PLANNING COMMISSION MEETING

**WHITE LAKE TOWNSHIP
PLANNING COMMISSION
SEPTEMBER 17, 2026**

RE: Ginko Self Storage -Final Site Plan/Final Engineering Plan Review-4th Review
~~Stormwater Maintenance Agreement Review-1st Review~~

Revised Final Site Plan Review for Special Land Use for White Lake Charter Township, Michigan

DRAWING TITLE
UTILITY PROFILES

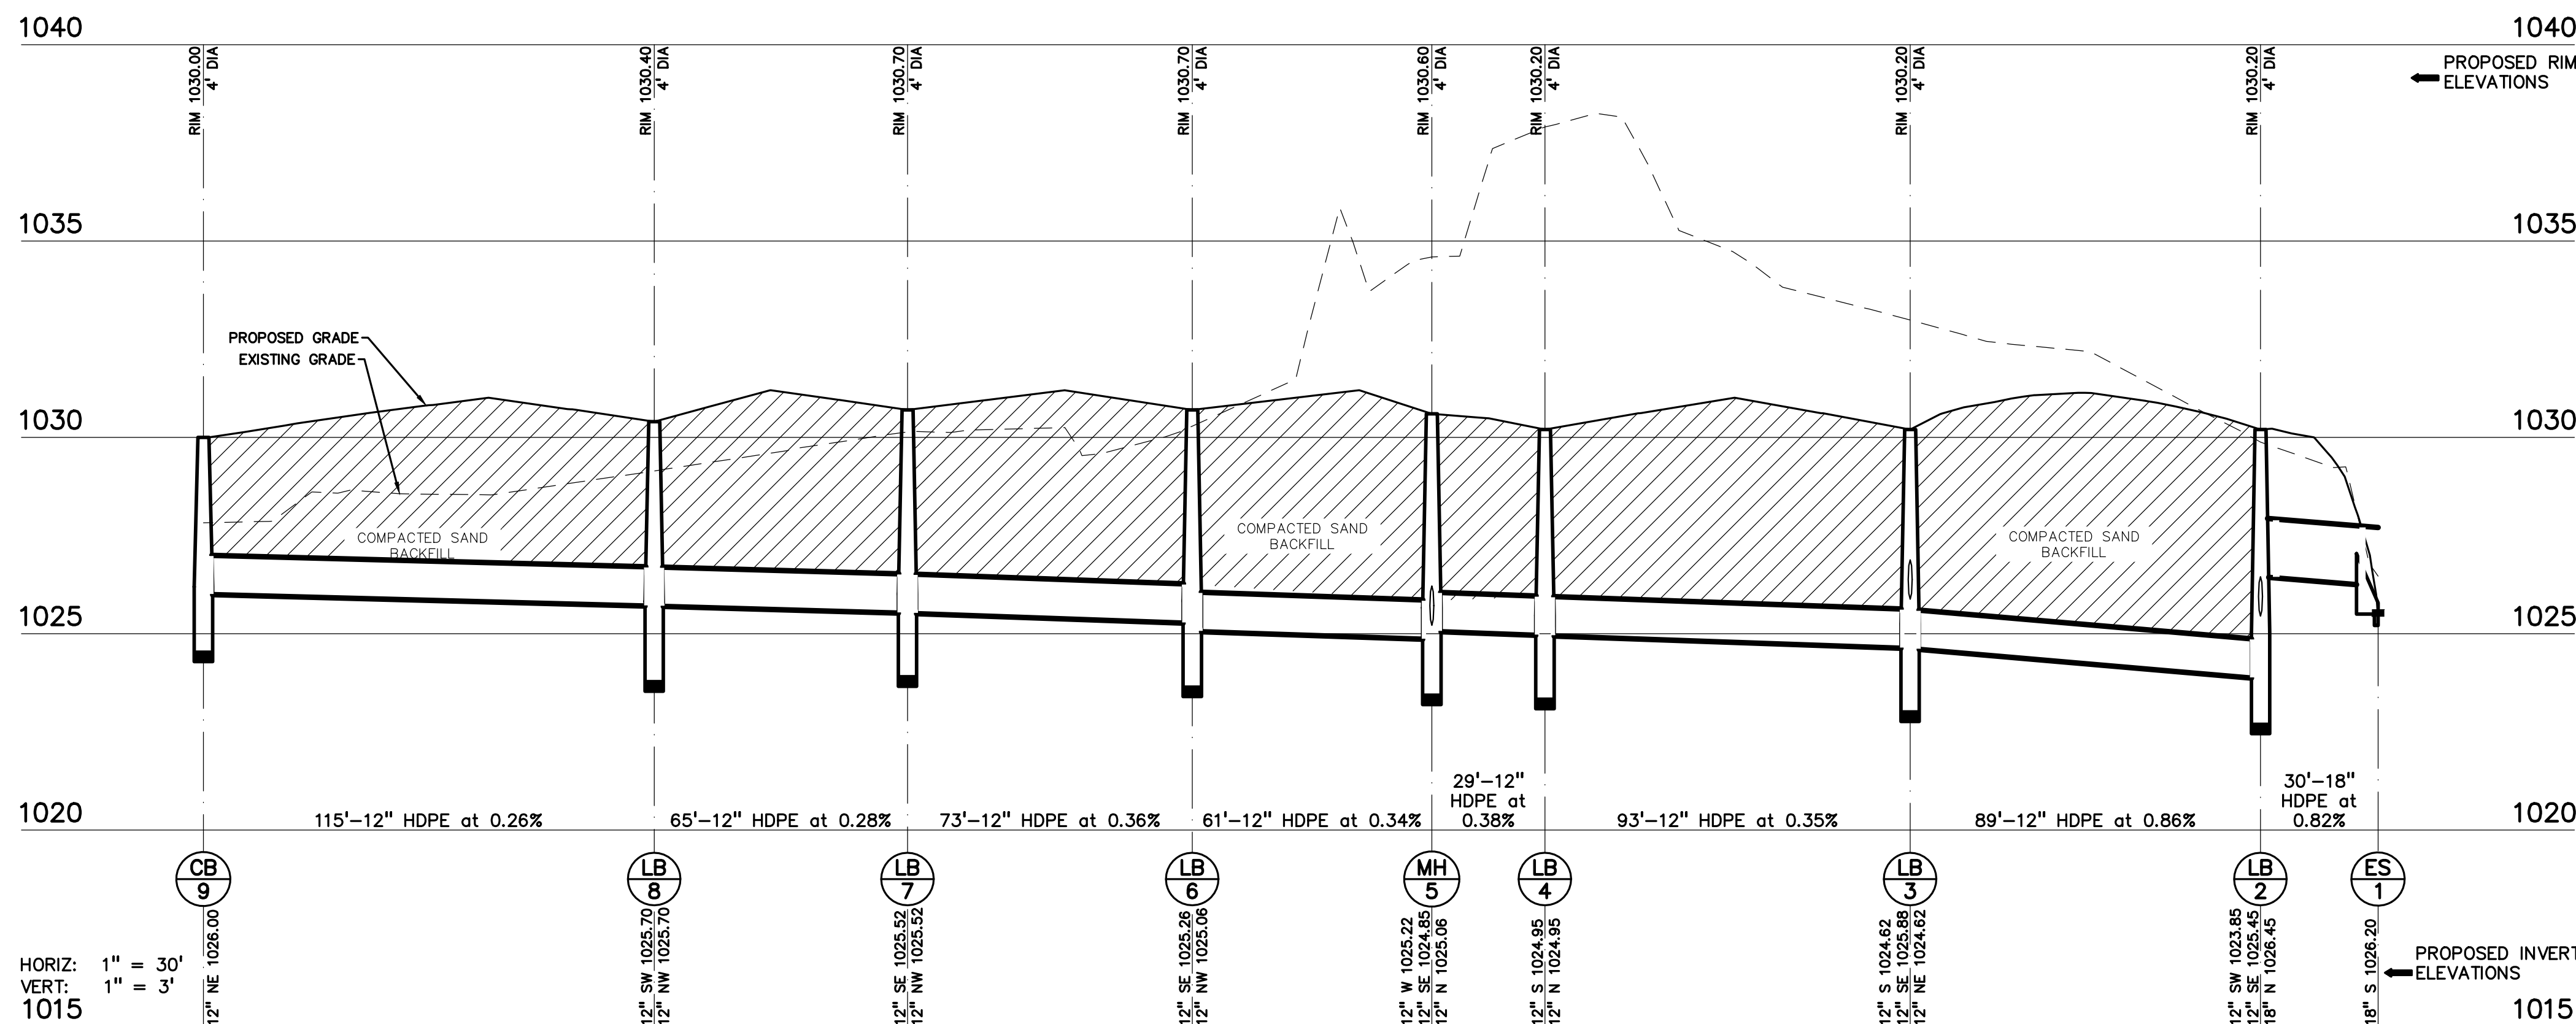
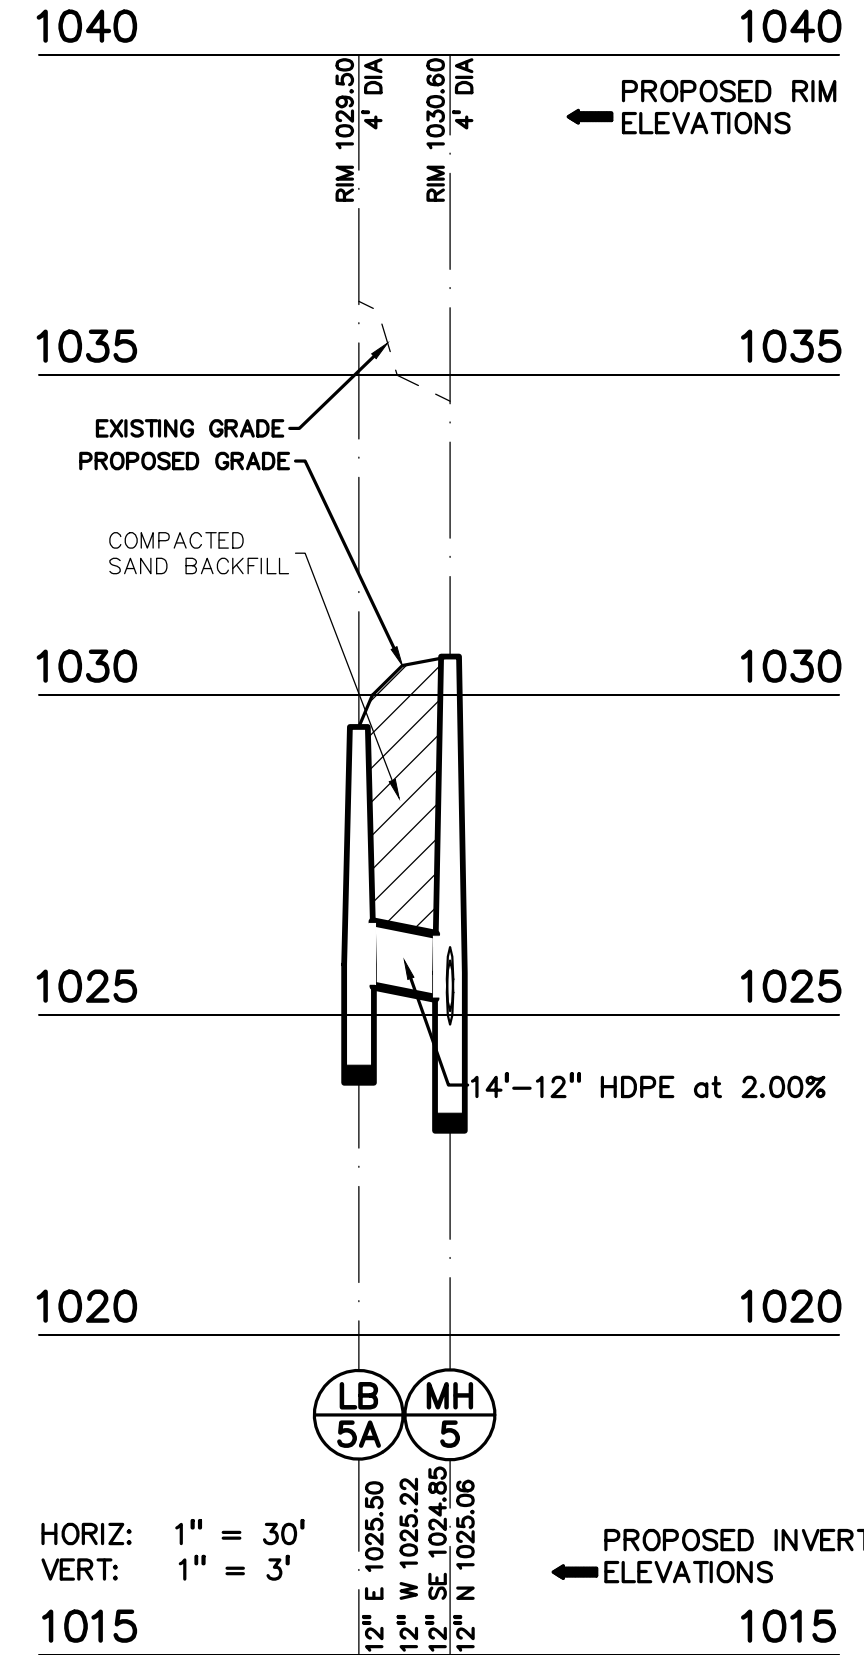
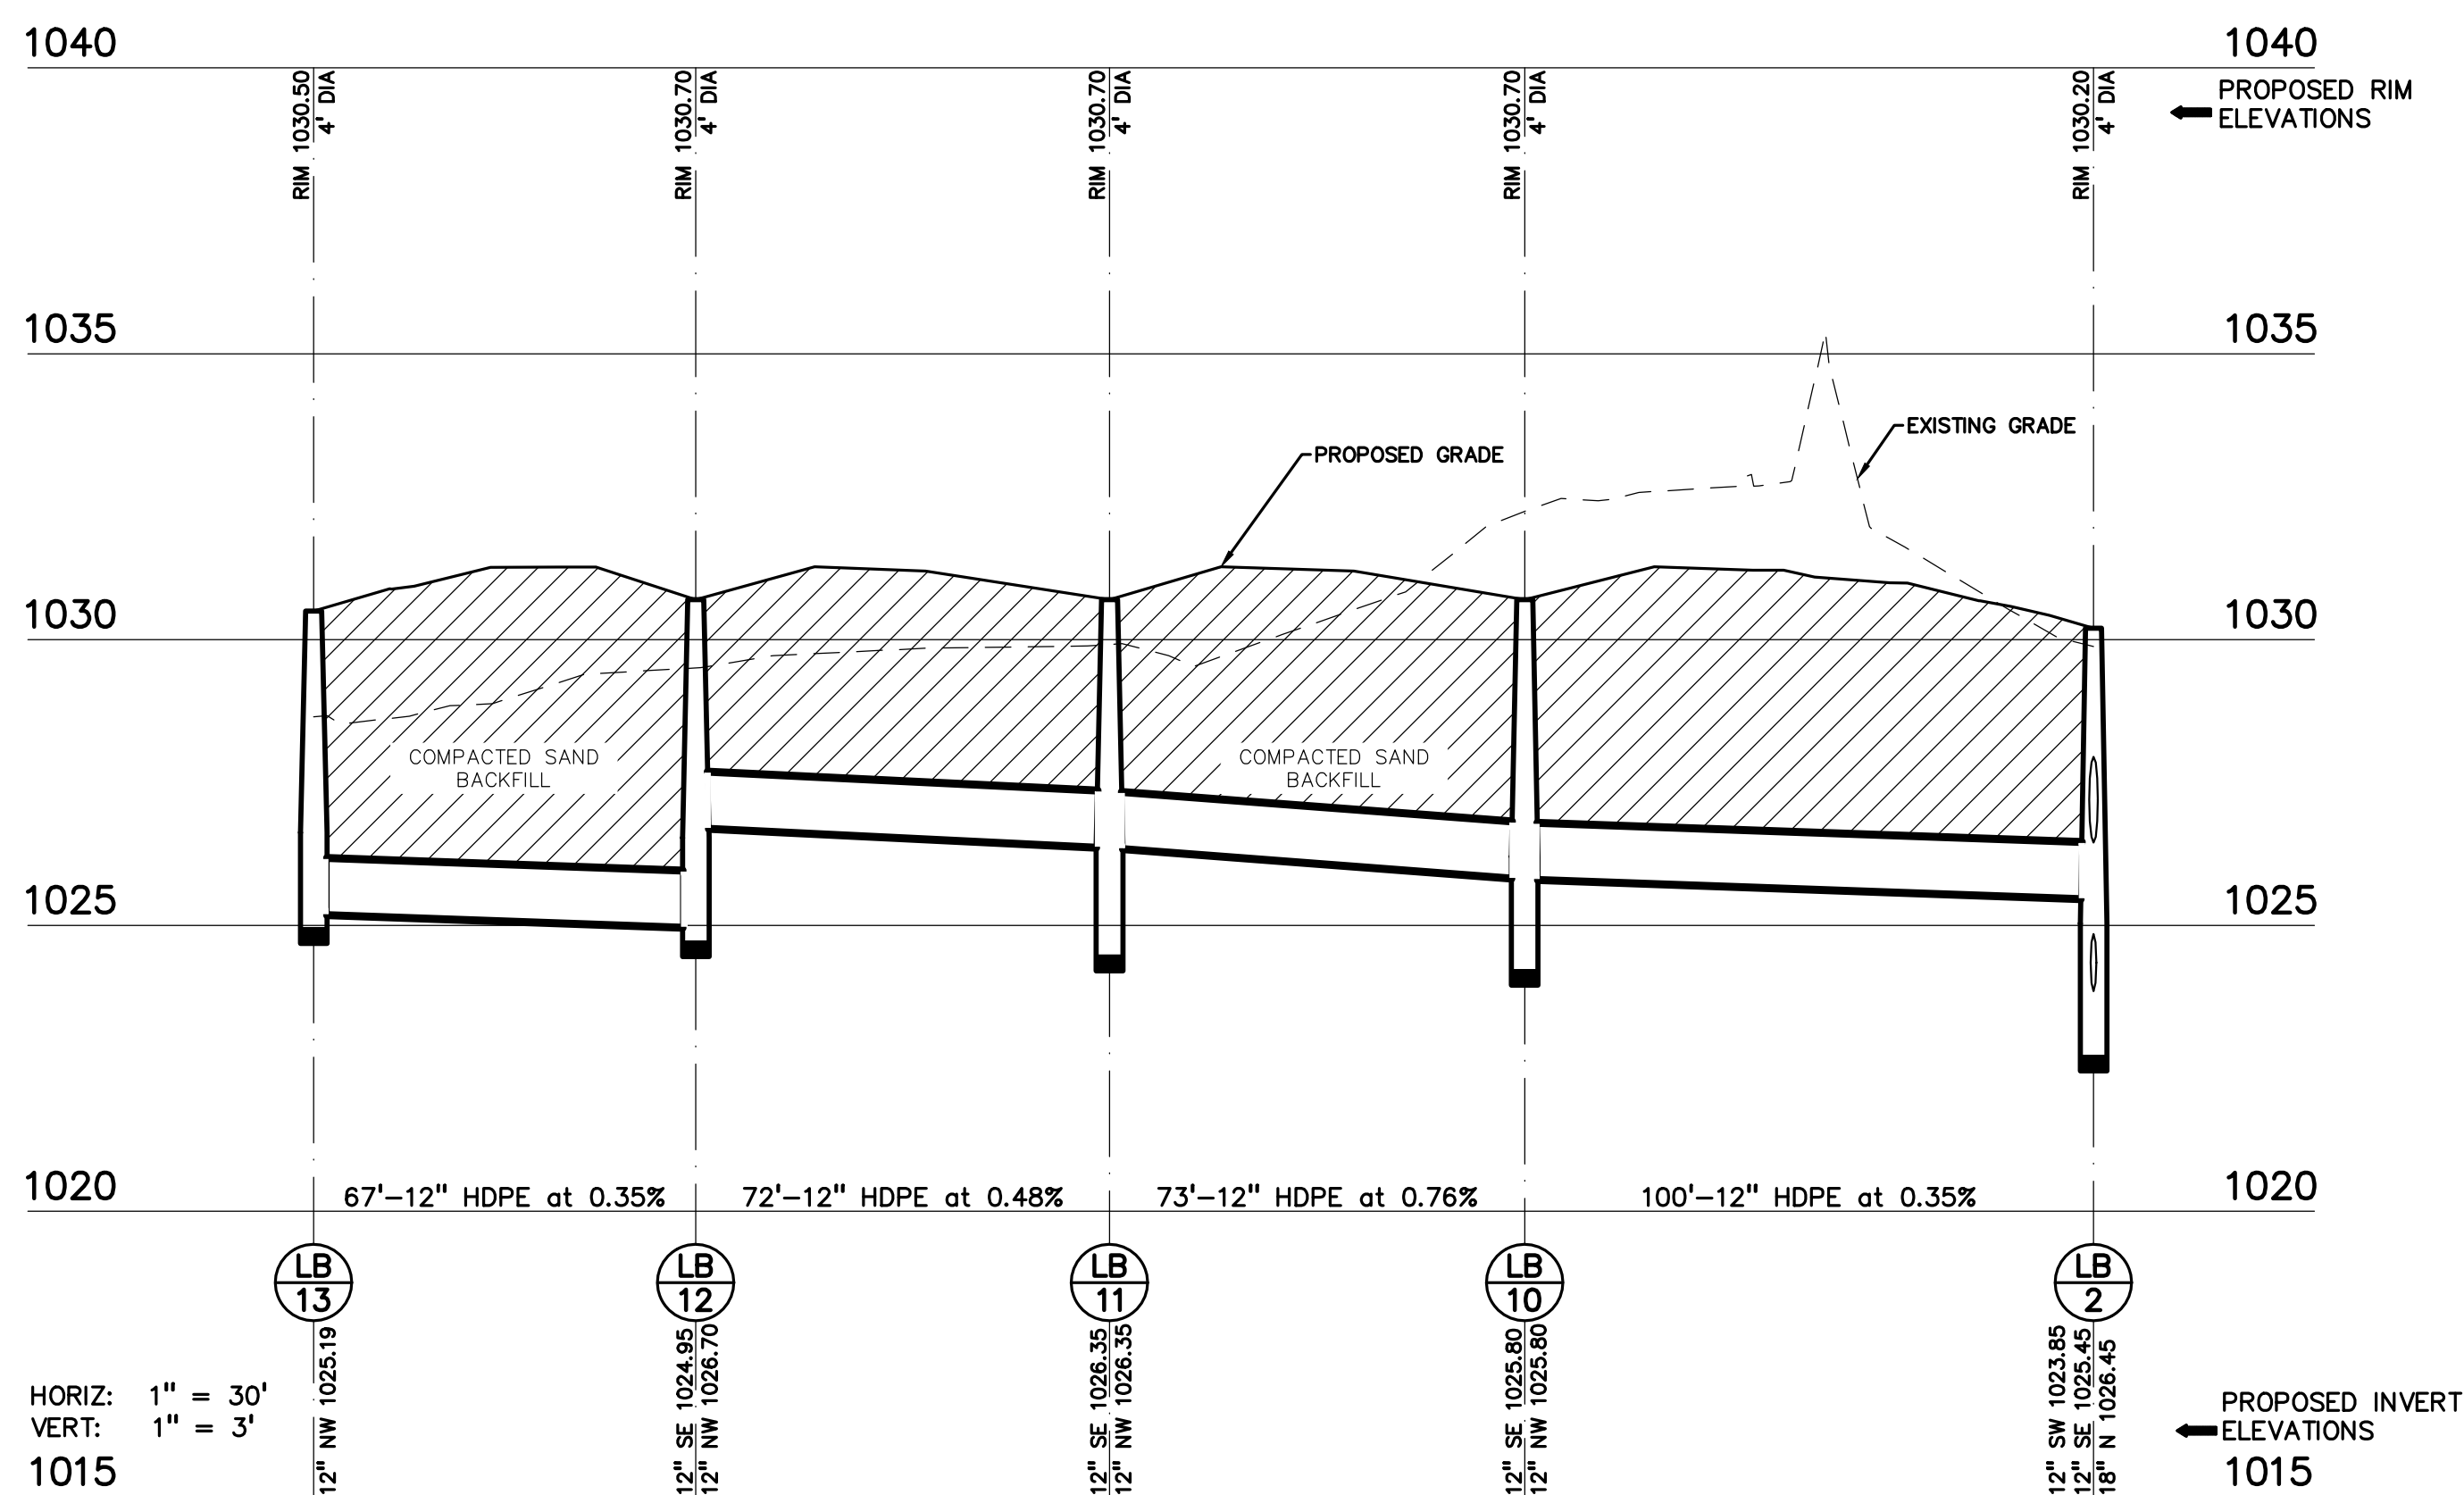
3. Sheet C-7.0- It appears that profiles were not updated based on revised storm sewer structure rim and invert elevations. We have attached a red lined copy of this sheet.
